**SERVICE BULLETIN**

144

TRIM TAB DRIVE PIN CHECK

T67M260, T67M260-T3A.

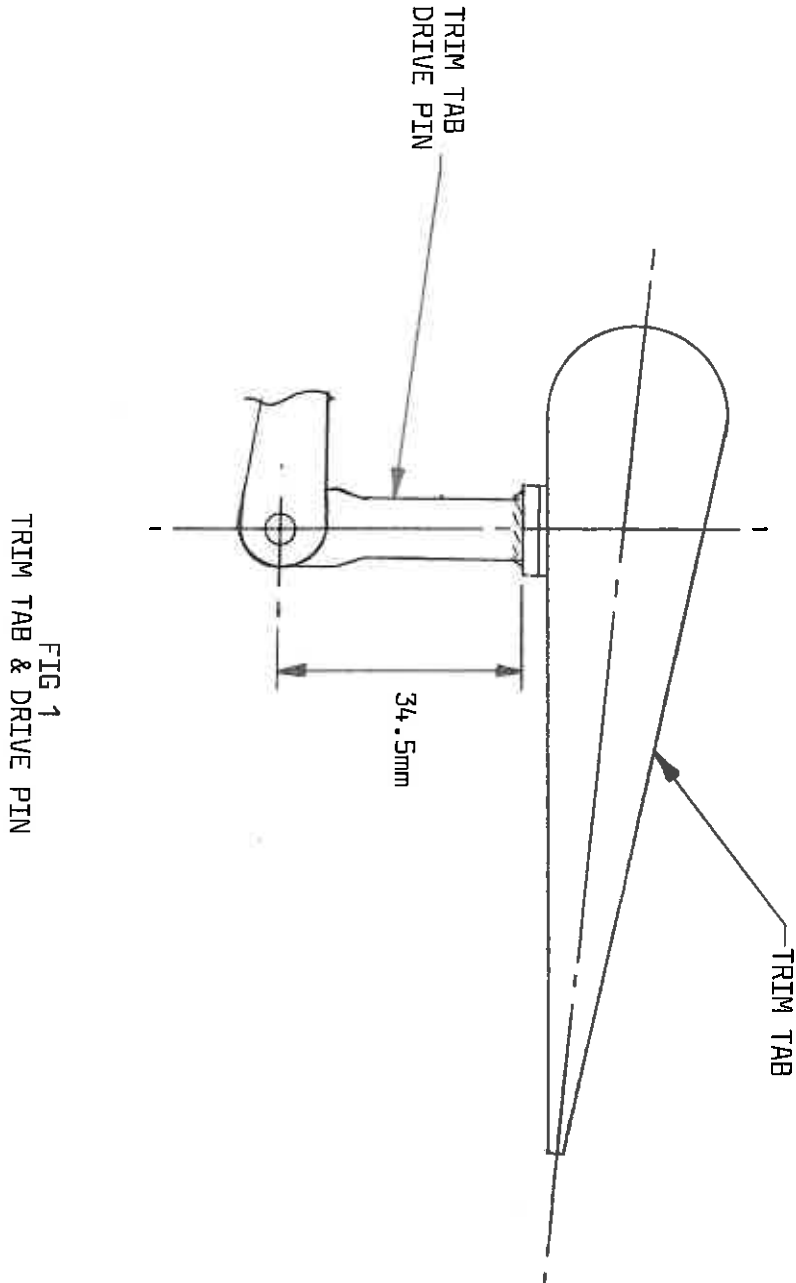
1. Locate elevator trim tab on port side of the elevator.
2. Measure dimension as indicated on Fig. 1.
3. The dimension on the correct trim tab drive pin (SAL Pt No. T67G-31-501) is 34.5mm. Incorrect drive pin (SAL Pt No. T67B-31-529) has a dimension of 44.5mm.

4. If Pt No. T67B-31-529 is found to be fitted, it should be replaced with T67G-31-501.
5. If replacement is required, when fitting correct trim tab drive pin (Pt No. T67G-31-501) screw up tight against lower surface of trim tab. To ensure correct alignment of drive pin, use either shim washer (SAL Pt No. T67B-51-533), washer (Pt No. 126-23-104) or thin washer (Pt No. 126-23-711) or any combination up to 2 washers and 1 shim washer. Use Loctite 636 on threads.
